30 September 2020
Our Ref: 9809A.15PS_s4.55(1A)_Mod 2

**RE: SECTION 4.55(1A) APPLICATION TO MODIFY SSD 8365 (MOD 2)
PENSURST PUBLIC SCHOOL
510 FOREST ROAD, PENSURST**

Figure 2 Proposed Landscape Plan

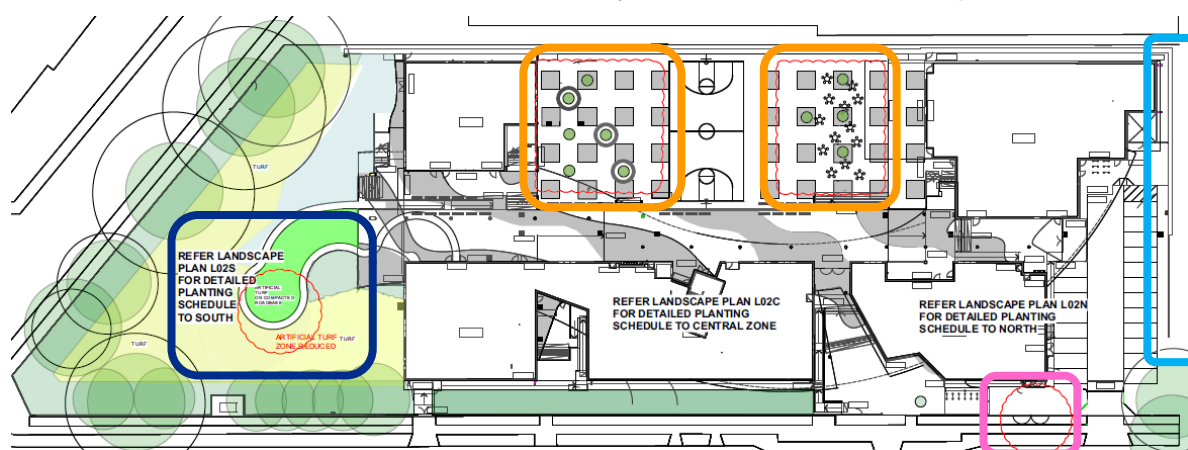
- Increase turfed area, decrease astro turf and re-align pathway and drainage (see **Dark Blue** mark up in **Figure 2**);
- Amend planting locations for ten (10) Crepe Myrtle (*Lagerstroemia* 'Natchez') trees (see **Orange** mark up in **Figure 2**) with no change to total number of plantings;
- Change tree species along boundary to Lilly Pilly (*Acmena smithii* 'Redhead') in order to limit crown spread and reduce overhanging branches over boundary (pursuant to discussions and agreement with neighbours) (see **Light Blue** mark up in **Figure 2**);
- Install new double gate to allow access for Fire Brigade (see location identified in **Pink** in **Figure 2**); and
- Extend brickwork to roof line on northern façade (see **Red** bubble in **Figure 3**).
